**IMPERIAL METALS CORPORATION  
MT. POLLEY PROJECT**

**RESPONSE TO REVIEW COMMENTS  
ON TAILINGS EMBANKMENT DESIGN  
(REF. NO. 1625/6)**

**JANUARY 25, 1996**

TAILINGS STORAGE FACILITY  
TAILINGS EMBANKMENT  
SECTIONS AND DETAILS

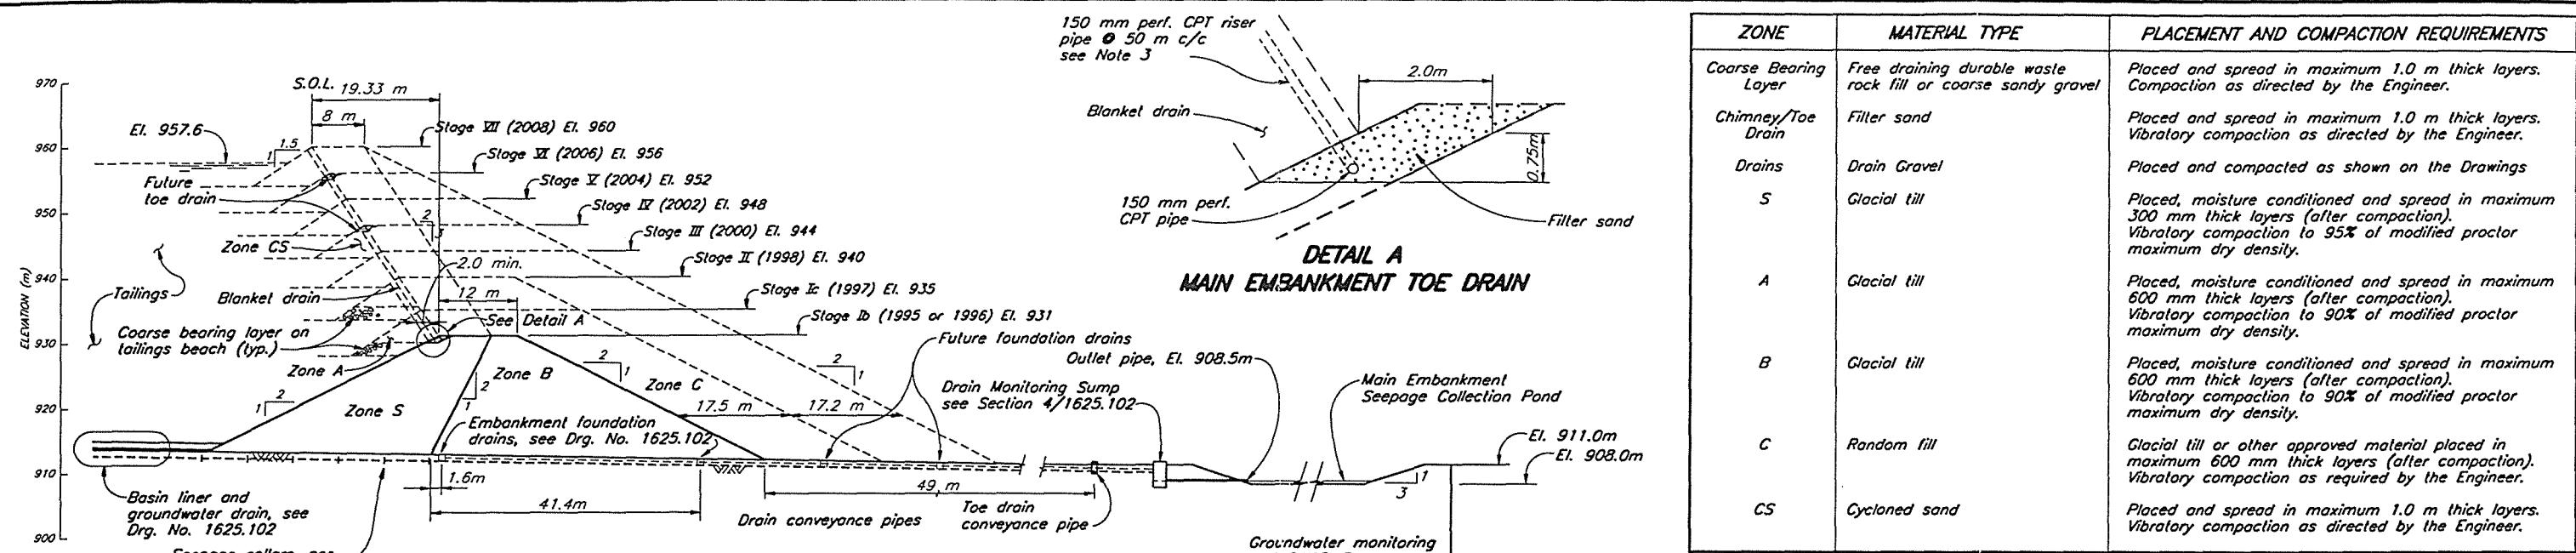
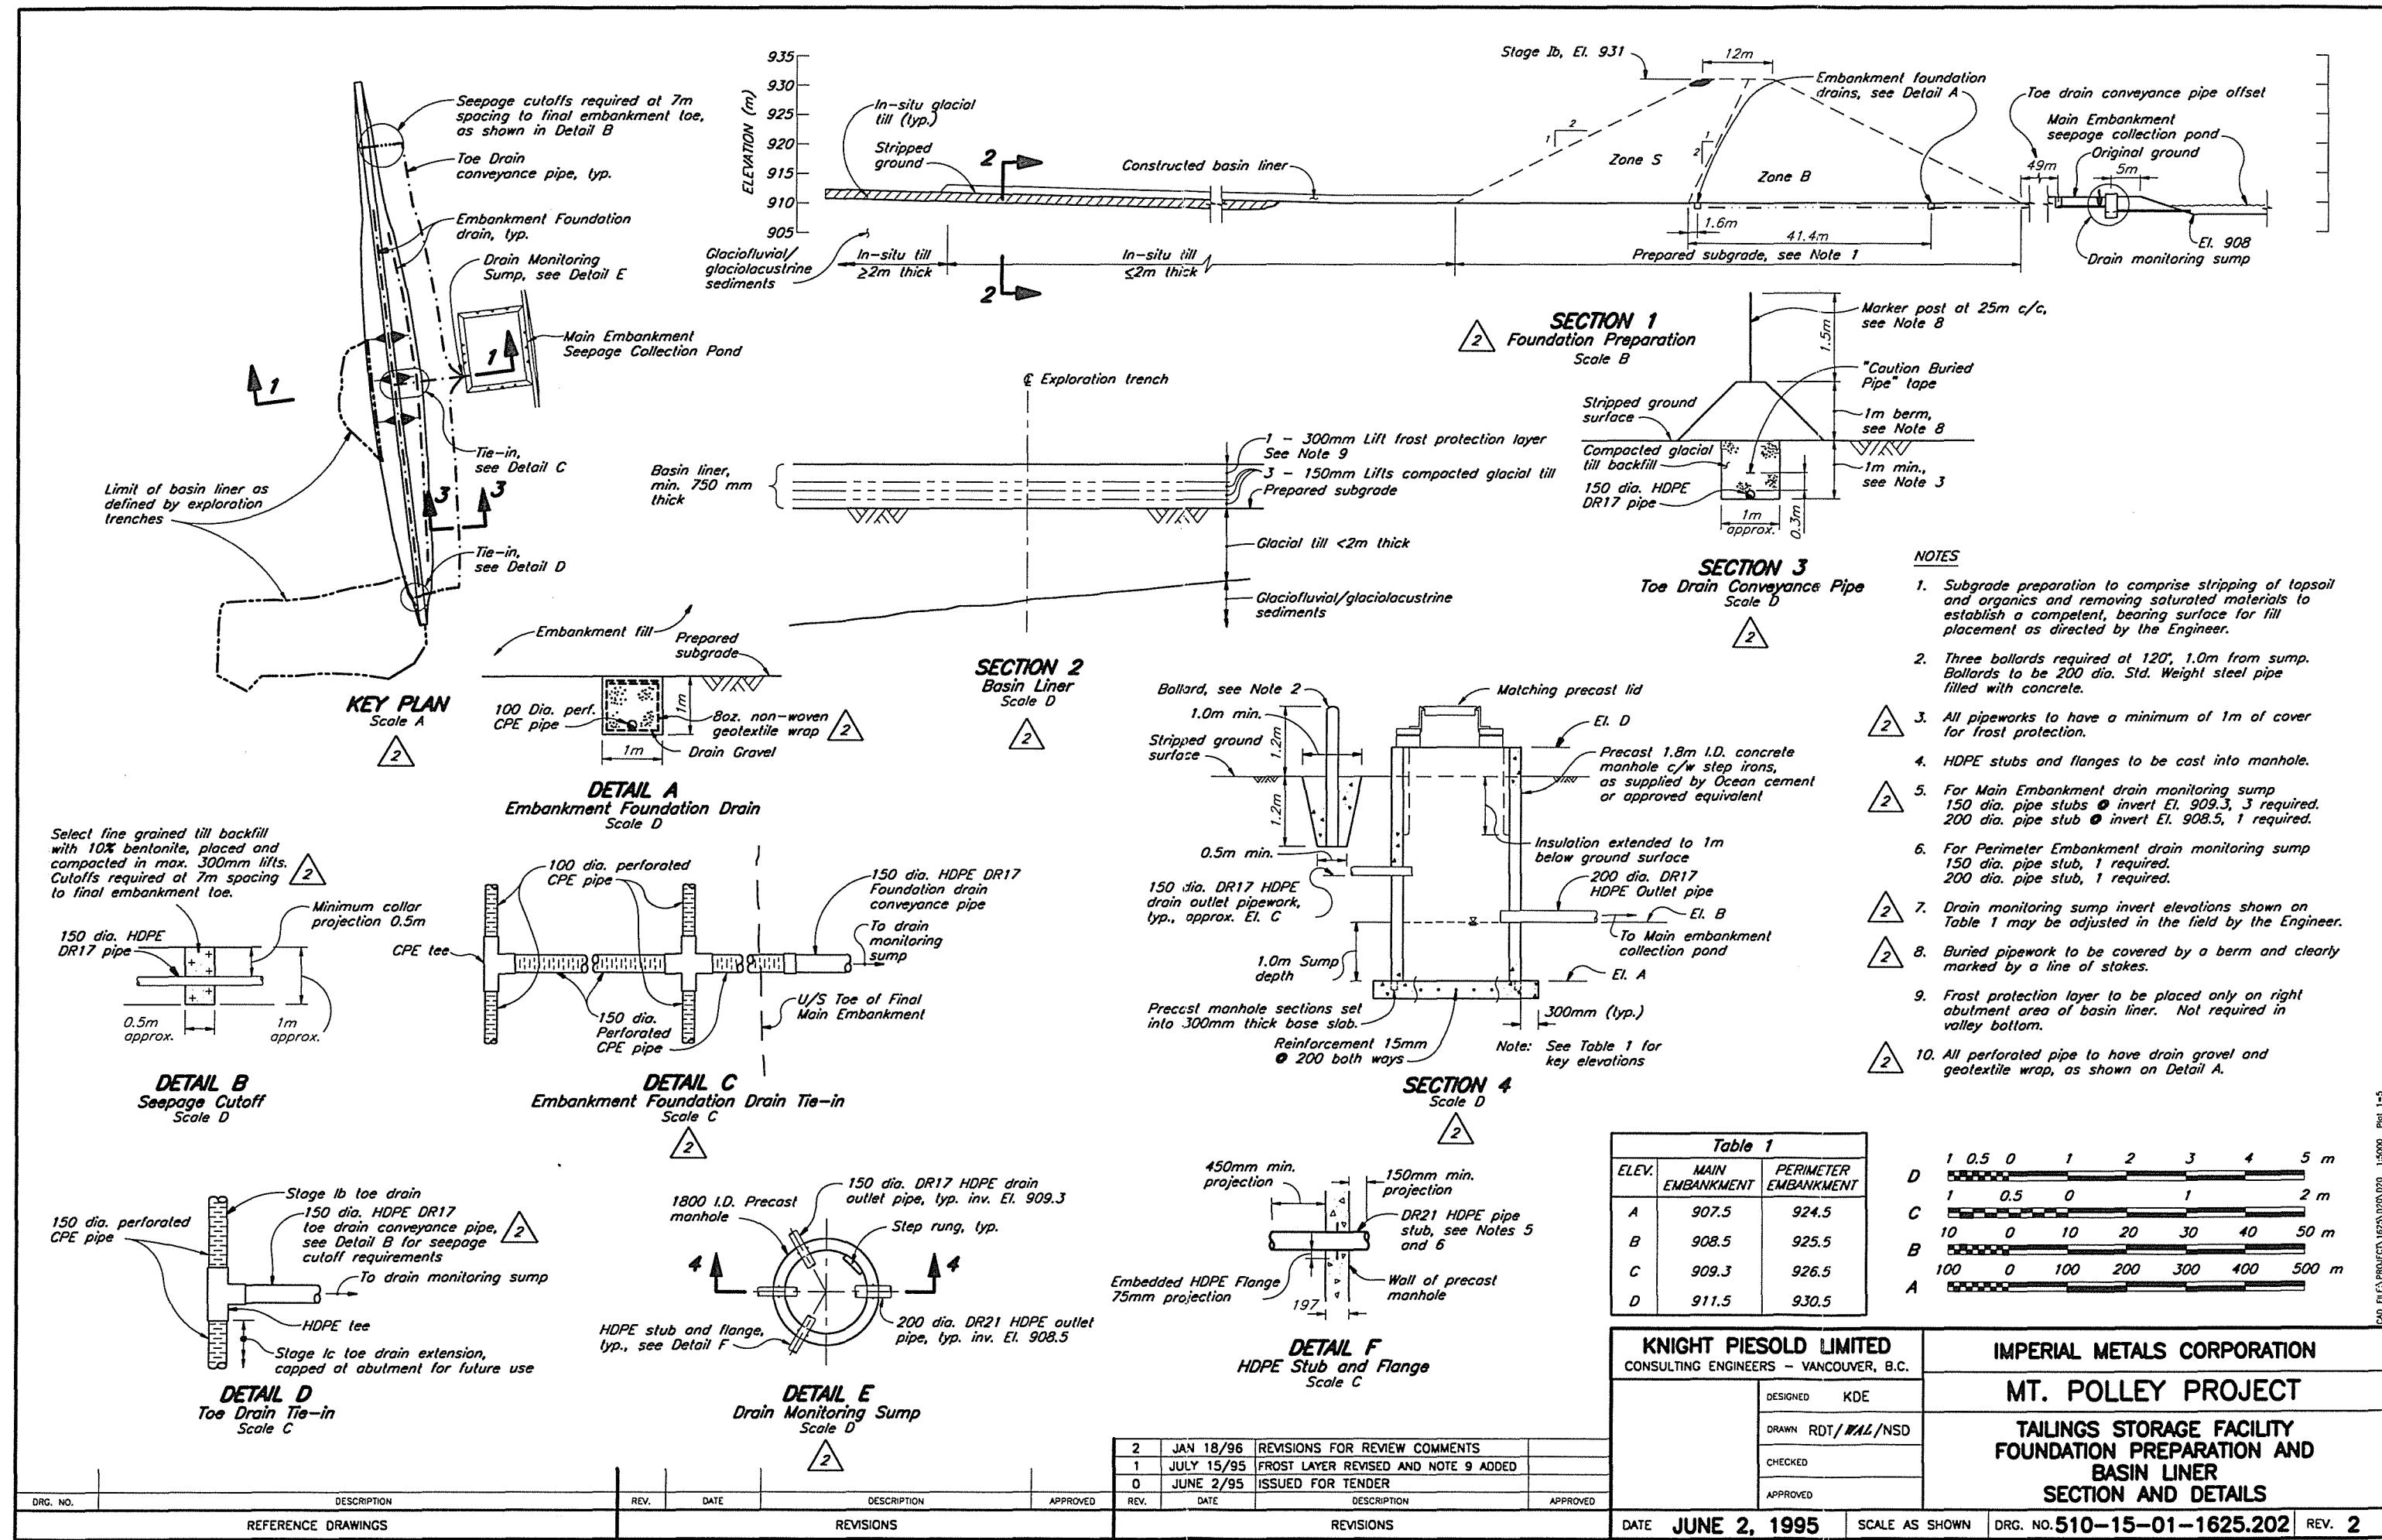
*The design proposed entails some of the compacted main dam to be constructed over loose to medium dense tailings. With this design variability in consolidation characteristics would be expected. This could lead to tension cracks near the top of the main dam and generally parallel to C.L. Stability analysis should allow for 10 m deep tension cracks filled with water.*

*Vibratory compaction of the beach should also be considered for the beach zone in the zone downstream of the S.O.L. to ensure low compressibility results.*

The modified centreline construction method is illustrated on Drawing 1625.111. As in the centreline construction method, the embankment fill zones extend onto the tailings beaches during each staged expansion. The tailings beaches will be comprised of sandy materials with a very high coefficient of consolidation. The compressibility of these materials will also be low and any settlements which result from on-going expansion of the embankment occur relatively rapidly and are complete during the construction period. In fact, one of the design requirements for each of the staged expansions on to the tailings beaches is for monitoring with vibrating wire piezometers in order to identify the development and dissipation of any excess pore pressures during construction. It has been our experience that any excess pore pressures which develop in the tailings tend to dissipate relatively quickly and the technical specifications include provisions for monitoring to ensure that the pore pressures have dissipated (and consolidation is therefore completed) prior to placement of each successive lift. Vibratory compaction of the first lift typically results in the largest pore pressure response in saturated tailings, after which successive lifts show progressively lower response to loading. The compressibility of the tailings decreases in response to the densification which results from loading and

compaction so that compression of the tailings during future staged expansions will not be significant.
